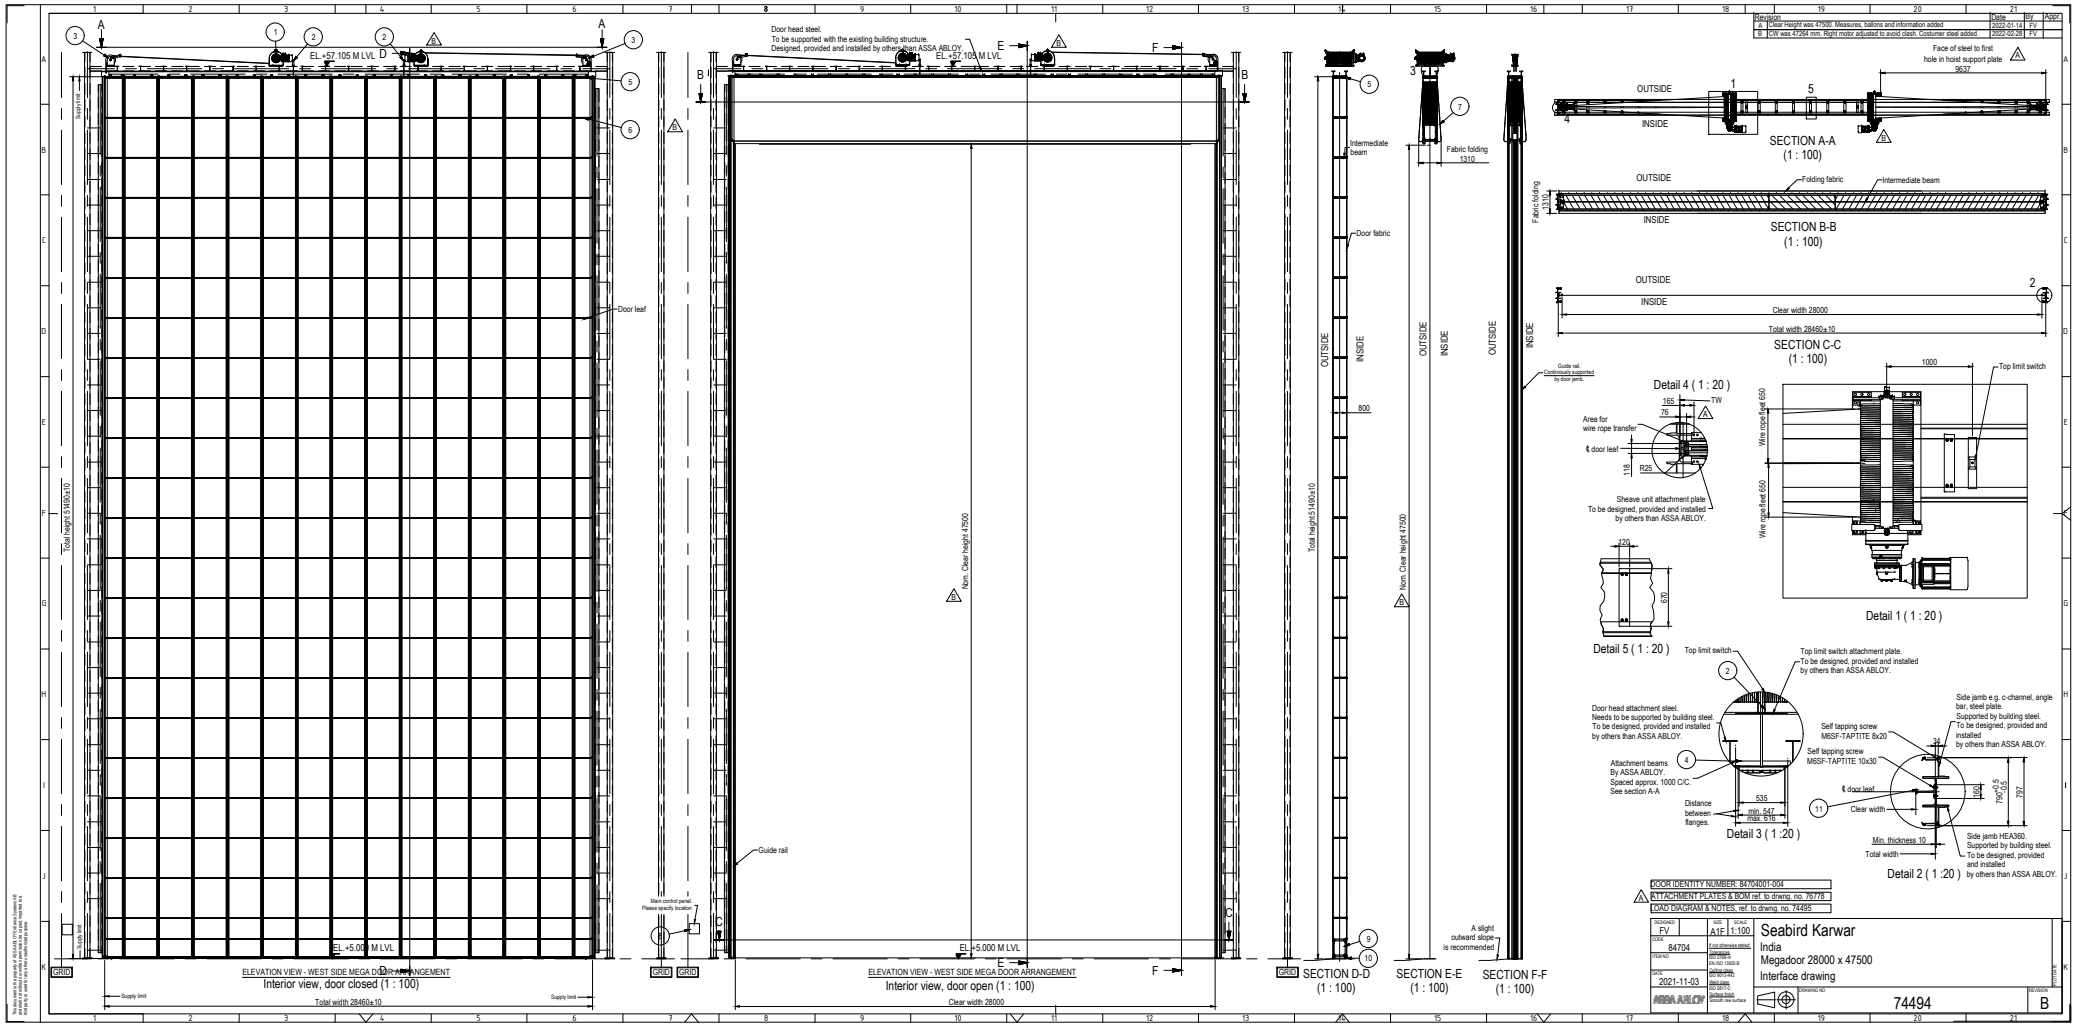
Revision	Date	By	Appr
A Clear Height was 47500. Measures, ballons and information added	2022-01-14	FV	
B CW was 47264 mm. Right motor adjusted to avoid clash. Costumer steel added.	2022-02-28	FV
